2. Name of Operator			Nana 30 Fed 1H
DEVON ENERGY PRODUCTION COMPANY, LP			9. API Well No.
3. Address and Telephone No.			30-025-39365
20 North Broadway, Oklahoma City, OK 73102-8260 405-552-8198			10. Field and Pool, or Exploratory
 Location of Well (Report location clearly and in accordance with Federal requirements)* 2310' FSL & 660' FEL Unit I Sec 30 T18S R32E 			Lusk; Bone Spring, North 11. County or Parish State
360 FSL & 660 FEL Unit P Sec 30 T18S R32E			Lea ✓ NM

Devon Energy Production Co., LP NM-98189 – Nana 30 Federal #1H API: 30-025-39365 Lea County, New Mexico

RE: Change to BOP Plan – Conditions of Approval

11" x 5,000 psi BOP Stack

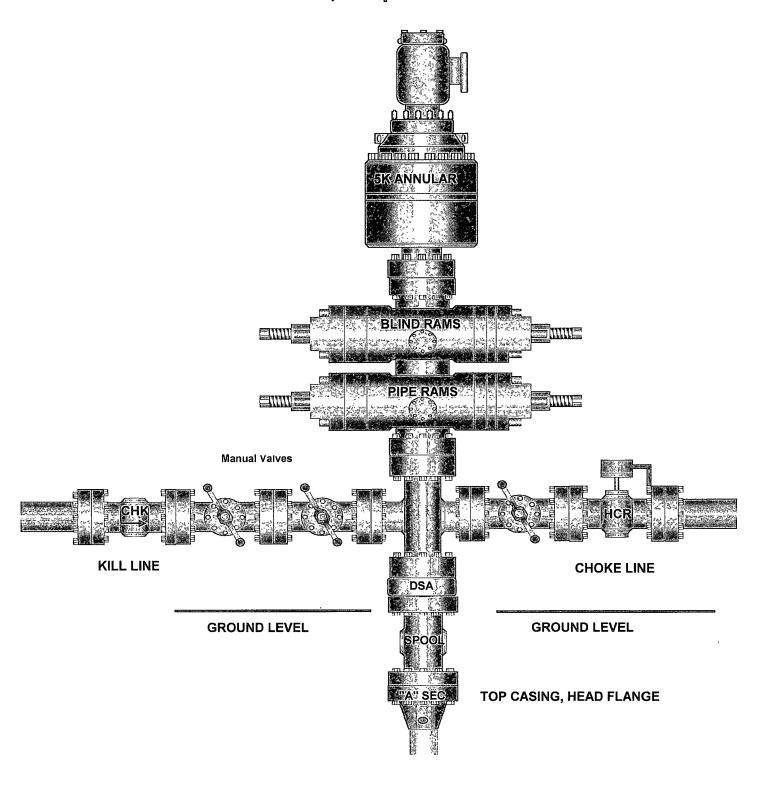
will be tested as per BLM Onshore The BOP system used to drill the position be tested as per BLM Onshore Oil The pipe rams will be operated an logged in the daily driller's log. A 2	intermediate hole will cone Oil and Gas Order No. 2 production hole will consil and Gas Order No. 2 as did checked each 24 hour 2" kill line and 3" choke lireventer, additional BOP	nsist of an 41" 5M Double Figure 2 as a 3M system prior to dist of an 11" 5M Double Rais a 5M system prior to drilling period and each time the dise will be incorporated into	am-and Annular preventer. The BOP system rilling out the surface casing shoe. In and Annular preventer. The BOP system will g out the intermediate casing shoe. In a country of the hole. These tests will be the drilling spool below the ram BOP. In y cock, floor safety valve, choke lines, and
SEE ATTACHED FOR CONDITIONS OF APPROVAL

- 1. All blowout preventer (BOP) and related equipment (BOPE) shall comply with well control requirements as described in Onshore Oil and Gas Order No. 2 and API RP 53 Sec. 17.

- 2. Minimum working pressure of the blowout preventer (BOP) and related equipment (BOPE) required for drilling below the surface casing shoe shall be 2000 (2M) psi. Annular to be tested to 1500 psi.

- 3. Minimum working pressure of the blowout preventer (BOP) and related equipment (BOPE) required for drilling below the 7 intermediate casing shoe shall be 5000 (5M) psi. 5M system requires an HCR valve, remote kill line and annular to match. The remote kill line is to be installed prior to testing the system and tested to stack pressure.
